Docket Number:	97-AFC-01C
Project Title:	High Desert Power Plant (COMPLIANCE)
TN #:	210565
Document Title:	Opening Testimony
Description:	Opening Testimony
Filer:	Nancee Murray
Organization:	California Department of Fish and Wildlife
Submitter Role:	Intervenor
Submission Date:	3/1/2016 12:36:39 PM
Docketed Date:	3/1/2016

RE: High Desert Power Project (97-AFC-01C)

OPENING TESTIMONY OF THE CALIFORNIA DEPARTMENT
OF FISH AND WILDLIFE

Petition for Modification to Drought-Proof the High Desert Power
Project, Filed October 30, 2015

Figure 1

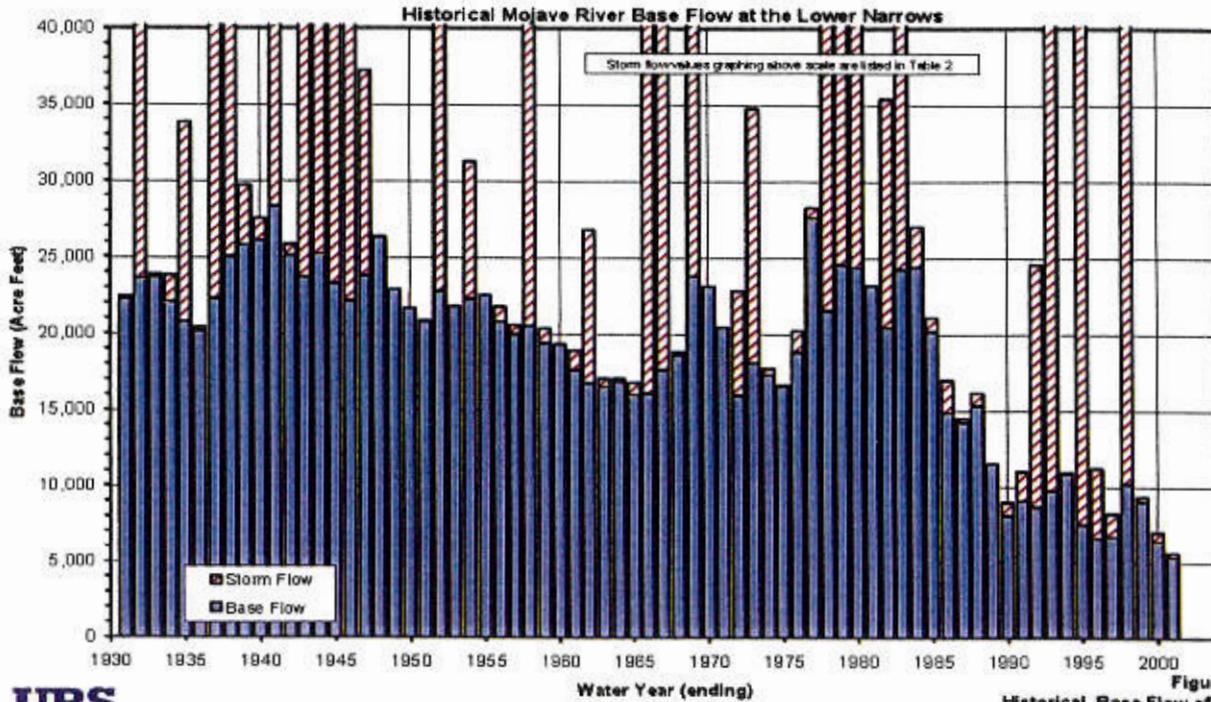
The lowest volume of Base Flow shown in Table 1 prior to 1996 was in Water Year 1994-95 at 7,472 AFY. Since 1996, Base Flow has systematically declined (Table 1, Figures 1 and 2) to where flows below 7,500 AFY have occurred 75% of the time, or 15 of the last 20 years. Base Flows near or below 4,500 AFY occurred 25% of the

time, or 5 of the last 20 years. The decline is temporarily reversed by Storm Flows, but the rise in Base Flow only lasts for approximately 3 years (Table 1, Figures 1 and 2) the continual decrease in Base Flow is a potentially significant impact to groundwater storage in the Transition Zone, which is located in the Alto Subarea as depicted in the Judgment, the same subarea in which the HDPP is located, and which affects the water levels and the sustainability of the riparian habitat in the Transition Zone.

Figures 1 and 2 show the historic levels of Base Flow at the Lower Narrows gauge from 1930s to 2015. Figure 2 also shows the Base Flow and VVWRA discharges since Water Year 1982-83. Table 1 lists the annual Base Flow and VVWRA discharge along
